[Docket No. FAA–2025–2546; Project Identifier AD–2025–01060–T]

Airworthiness Directives; The Boeing Company Airplanes

ACTION: Notice of proposed rulemaking (NPRM).

Figure 2 to Paragraph (i)—Fuel Feed Encapsulation

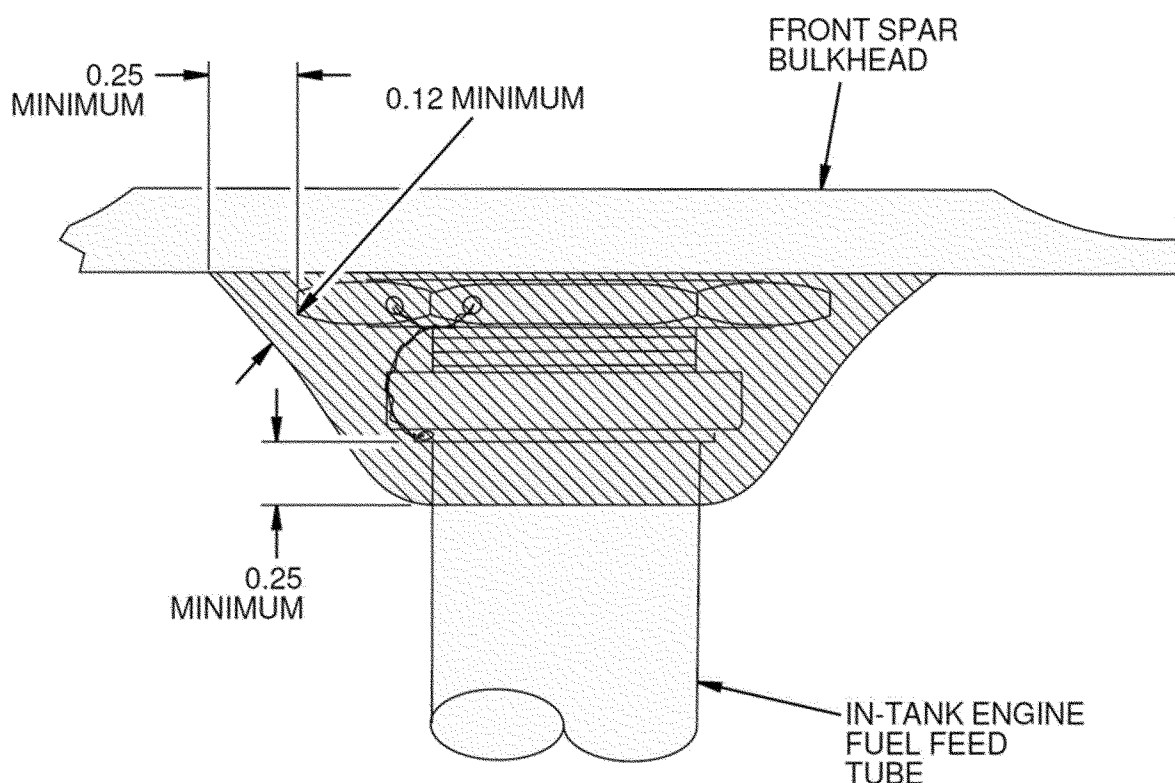
Within 60 days after the effective date of this AD, revise the existing maintenance or

inspection program, as applicable, to incorporate the information specified in Figure 1 and Figure 2 to paragraph (i) of this AD.
